DA NO: DA-2024/8
ADDRESS: 365 SAILORS BAY ROAD, NORTHBRIDGE NSW 2063.
PROPOSAL: ALTERATIONS AND ADDITIONS TO EXISTING DWELLING INCLUDING PARTIAL DEMOLITION, ROOFING, LANDSCAPING AND ASSOCIATED WORKS.
RECOMMENDATION: APPROVAL
ATTACHMENTS:
1. SITE DESCRIPTION AND AERIAL PHOTO
2. DEVELOPMENT CONTROLS, STATISTICS, DEVELOPER CONTRIBUTION & REFERRALS
3. APPLICANT'S CLAUSE 4.6 SUBMISSION – HEIGHT
4. OFFICER'S CLAUSE 4.6 ASSESSMENT – HEIGHT
5. APPLICANT'S CLAUSE 4.6 SUBMISSION – FSR
6. OFFICER'S CLAUSE 4.6 ASSESSMENT – FSR
7. SECTION 4.15 (79C) ASSESSMENT
8. SCHEDULE OF CONDITIONS
9. NOTIFICATION MAP
RESPONSIBLE OFFICER: CAITLIN MCNALLY – TEAM LEADER FAST TRACK
AUTHOR: LORI LI – DEVELOPMENT ASSESSMENT OFFICER
REPORT DATE: 2 JULY 2024
MEETING DATE FOR ED ELECTRONIC DETERMINATION

The purpose of this report is to seek determination by Willoughby Local Planning Panel (WLPP) of Development Application DA-2024/8 for alterations and additions to existing dwelling including partial demolition, roofing, landscaping and associated works at 365 Sailors Bay Road, Northbridge.

Figure 16 Overshadowing Diagrams

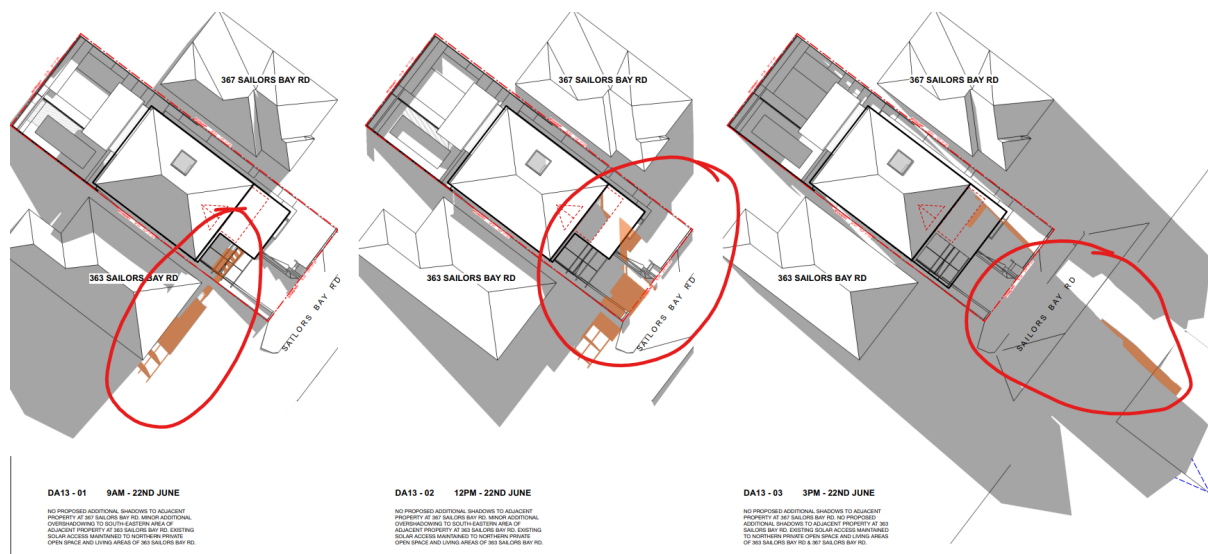
WDCP requires 3 hours of solar access between 9am and 3pm on 22 June to private open space and living areas of neighbouring properties.

The application was accompanied by shadow diagrams to demonstrate the impact of the proposed development upon adjoining and nearby development. The additional solar impact resulted from the proposal is considered to be within acceptable limits. The diagrams further demonstrate that the small extensions to the first floor do not create an unreasonable impact to neighbouring solar access.

Figure 17 Existing Height Noncompliance

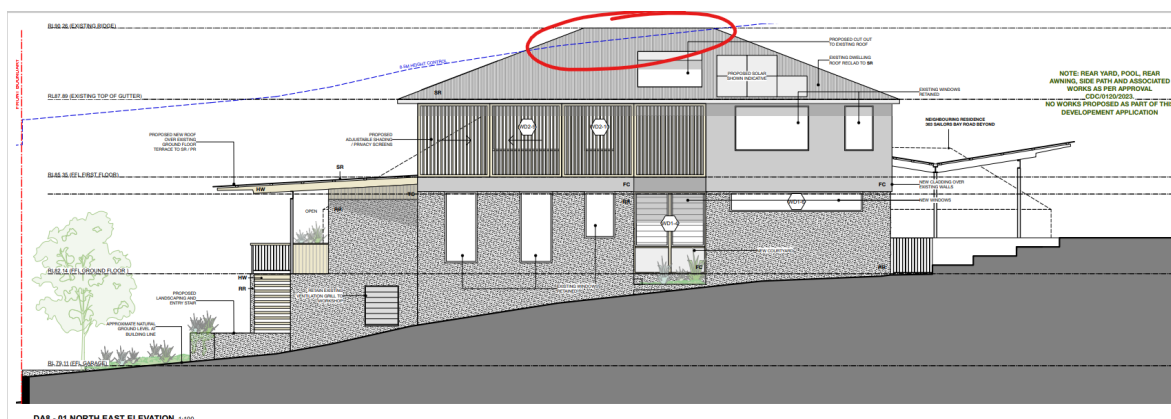
As shown on the submitted Architectural plans, primarily the South-western Elevation and Long Section, there is a minor non compliance to the South East end of the dwelling roof ridge which includes a portion of the existing roof space.

Further, a reduction to the existing roof height would result in significant modification to the existing and predominant scale and streetscape character of the site, and result in an unreasonable reduction to the existing habitable floor area thus impacting the overall amenity of the residents. A maintenance of the existing is considered a more sustainable construction option, and modifications purely to meet the standard are unnecessary.
